February 20, 2015
File No. 89220
Via Email and U.S. Mail

Town of Carlisle, Zoning Board of Appeals
ATTN. Steve Hinton
66 Westford Street
Carlisle, MA 01741
shinton@mindspring.com

**Re: Phase 1 Report
Independent Hydrogeologic Study
100 Long Ridge Road, Carlisle, MA**

FIGURE 2

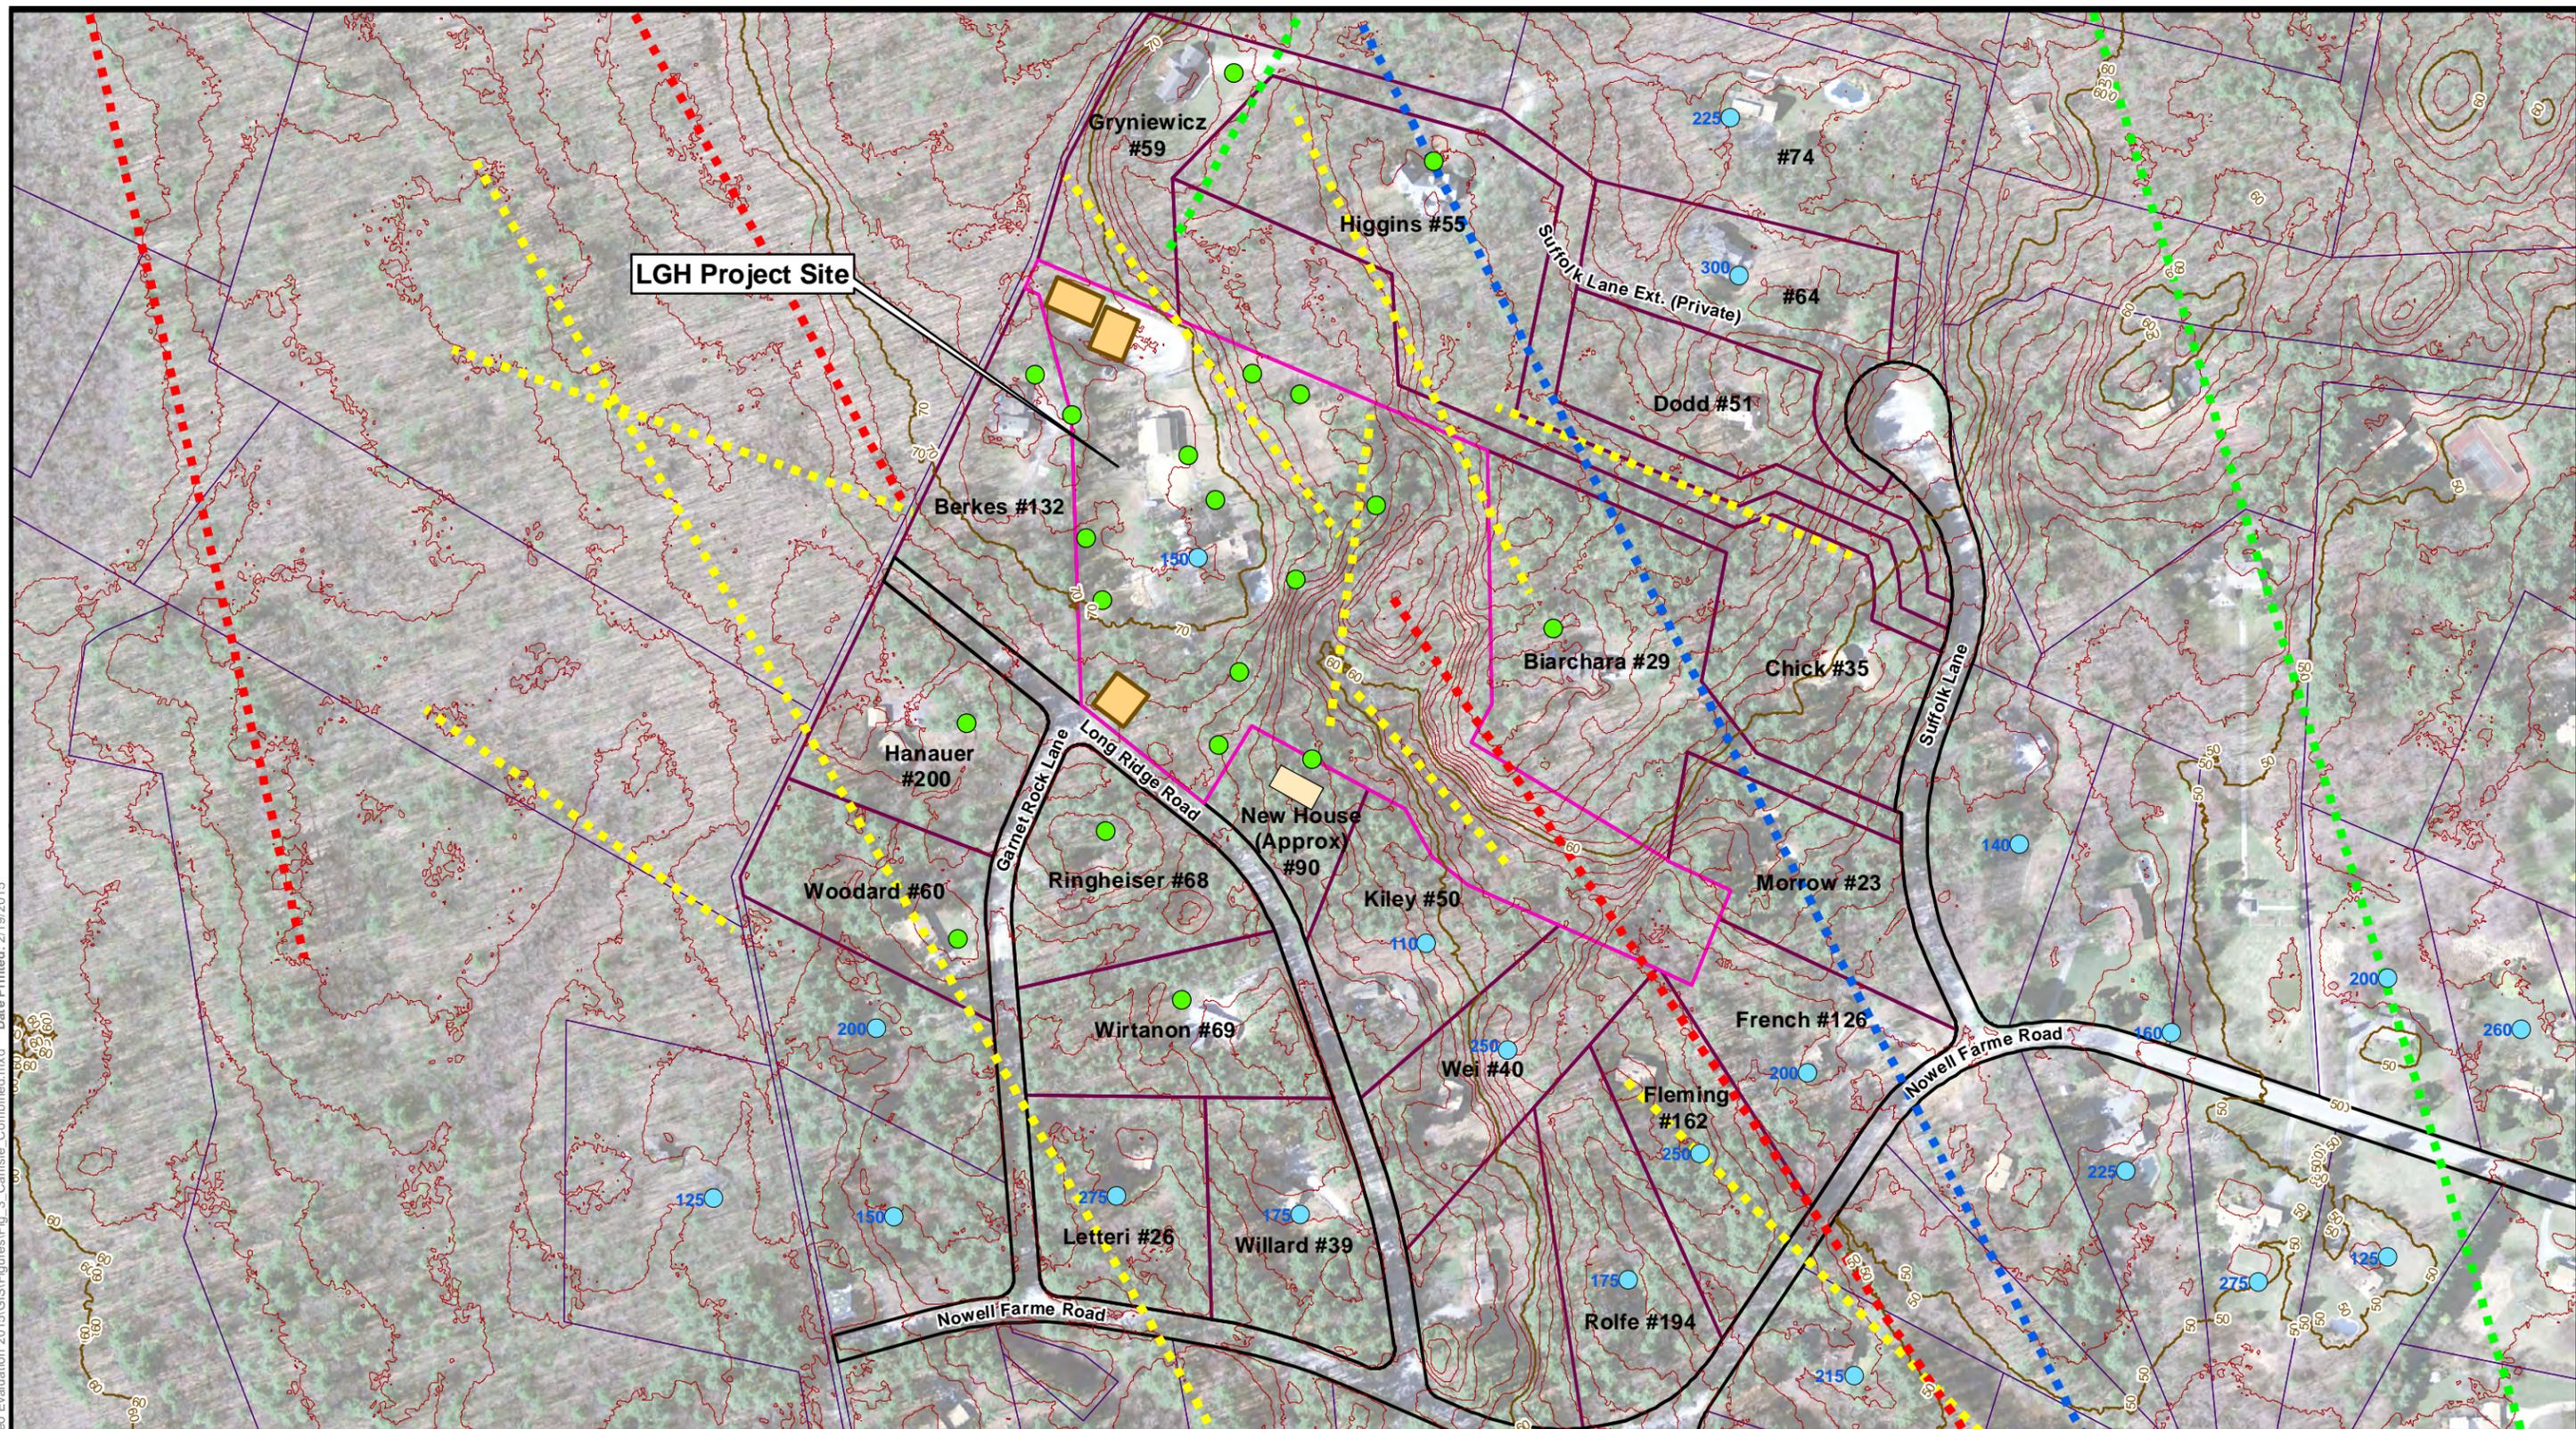
While at the Site, Nobis observed boulders throughout and one small, possible bedrock outcrop (may be a boulder) near the western edge of the property. In the northwestern corner of the property, where septic disposal areas 2 and 3 are planned (Figure 2), the area is cleared for

Figure 3 does not show any photolineaments directly passing through any of the three proposed septic disposal areas. However, a NW-SE photolineament traverses the area just northeast (topographically downhill) from proposed septic disposal areas #2 and #3. Although the groundwater potentiometric surface ("water table") in the overburden and the groundwater flow

direction have yet to be mapped, the groundwater gradient and flow direction appear to be directed to the northeast from proposed septic disposal areas #2 and #3, based on topographic contours obtained from MASSGIS (Figure 2). Overburden groundwater flow direction in the vicinity of proposed septic disposal area 1 is less clear, based on available topographic contours, but is probably to the SW, S, and SE (Figure 2). The surface contour map and groundwater contour map to be developed by LGH (BREM_148 01.09.2015) will aid greatly in predicting overburden groundwater flow directions in the vicinity of the proposed septic disposal areas. Even with this information, however, possible flow paths to the proposed and existing bedrock wells will not be predictable with confidence.

FIGURE 3

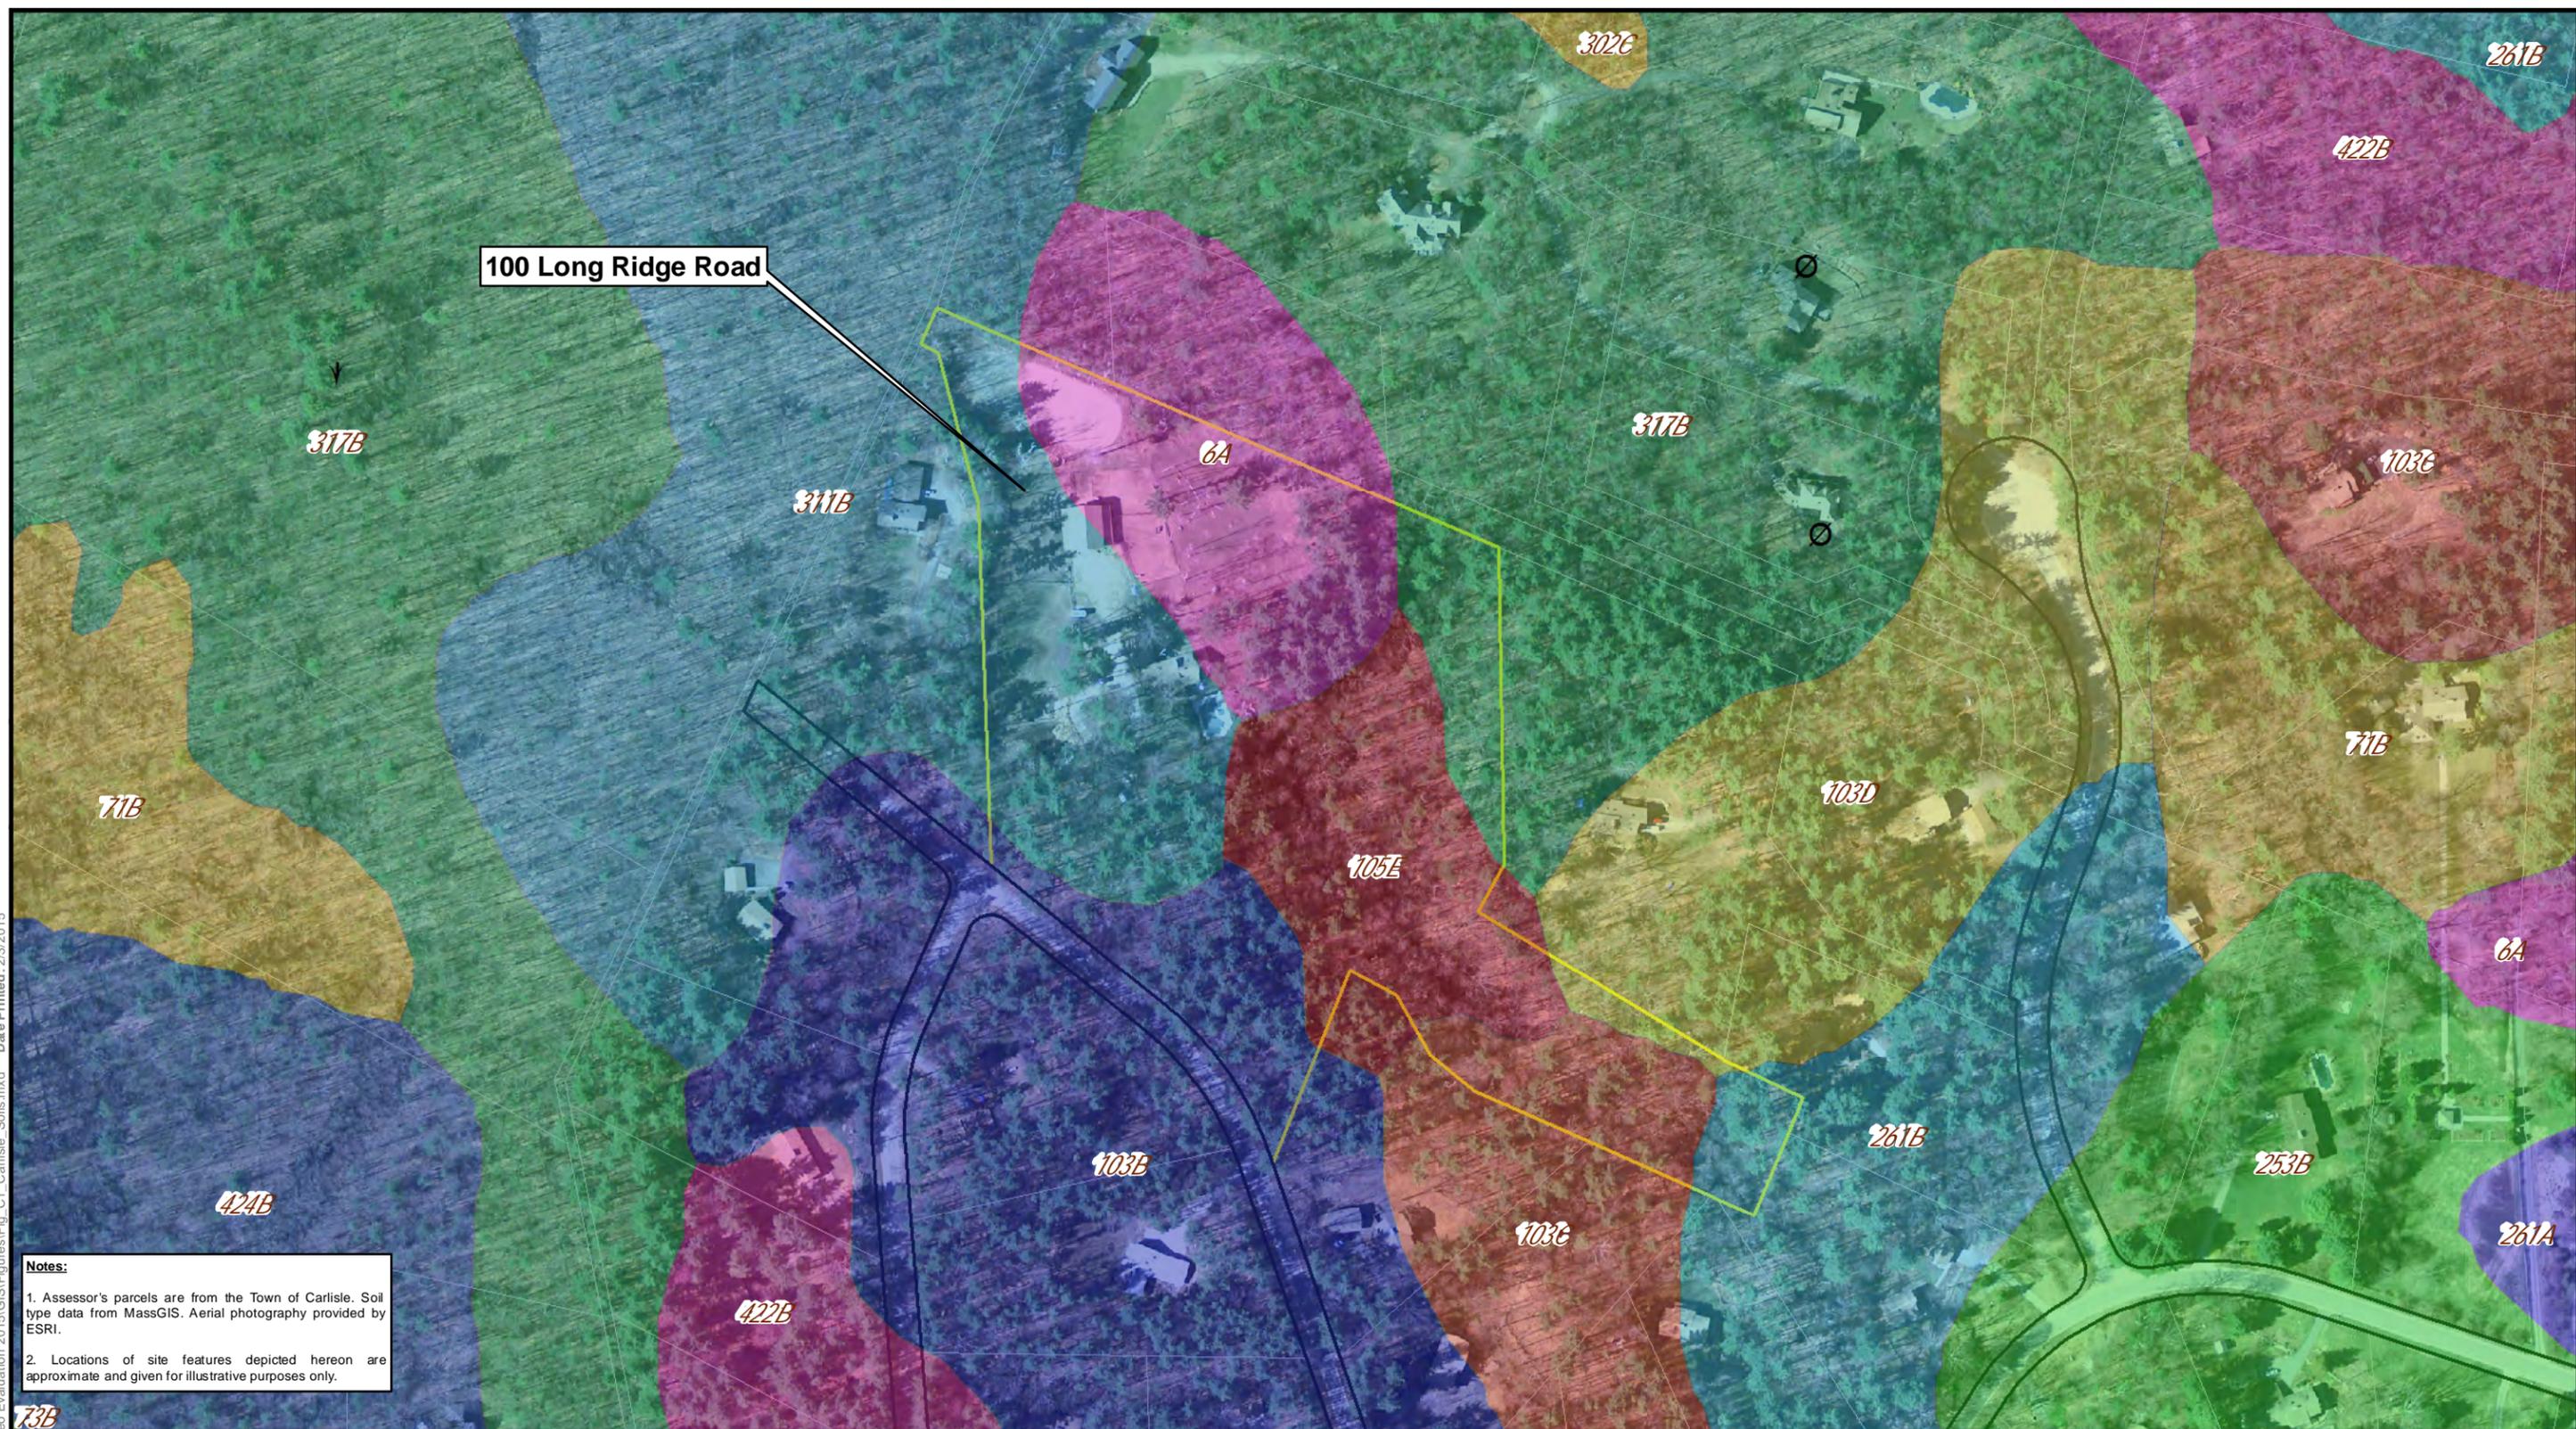
The results show that few strong or intermediate lineaments are present in the area (map in Attachment D) and that all the lineaments that occur on Site or on abutters' properties are subtle (Figure 3). The most common lineament orientation is northwest to southeast (NW/SE), although a north-northeast (NNE) trending lineament is present near the eastern edge of the Site. This lineament probably coincides with the brook, wetland, and northeast-trending outcrop in that location and may indicate that a steeply dipping bedrock fracture zone is present in this area. Such a fracture zone can potentially receive recharge from the overburden and soils that overlie it and can serve as a migration pathway for groundwater, possibly connecting bedrock wells with each other or with groundwater discharged at a septic disposal area.

Figure 3 shows photolineaments on the Site and the abutters' properties, superimposed on a map of the Site and vicinity with existing and proposed wells and the proposed septic disposal areas. Because these lineaments may represent bedrock fracture zones, they may be pathways for groundwater flow and contaminant transport. It must be remembered that photolineaments are not guaranteed to be fracture zones, and their location, especially from high altitude photographs, is only approximate. Nonetheless, Figure 3 can serve to focus investigations on some proposed wells and existing abutters' wells that may be of more concern than others. For example, northwest-to-southeast (NW-SE) trending lineaments project southeastward from the site (yellow and red dashed lines on Figure 3) may indicate that future studies should include detailed assessments of wells to the southeast of the Site.
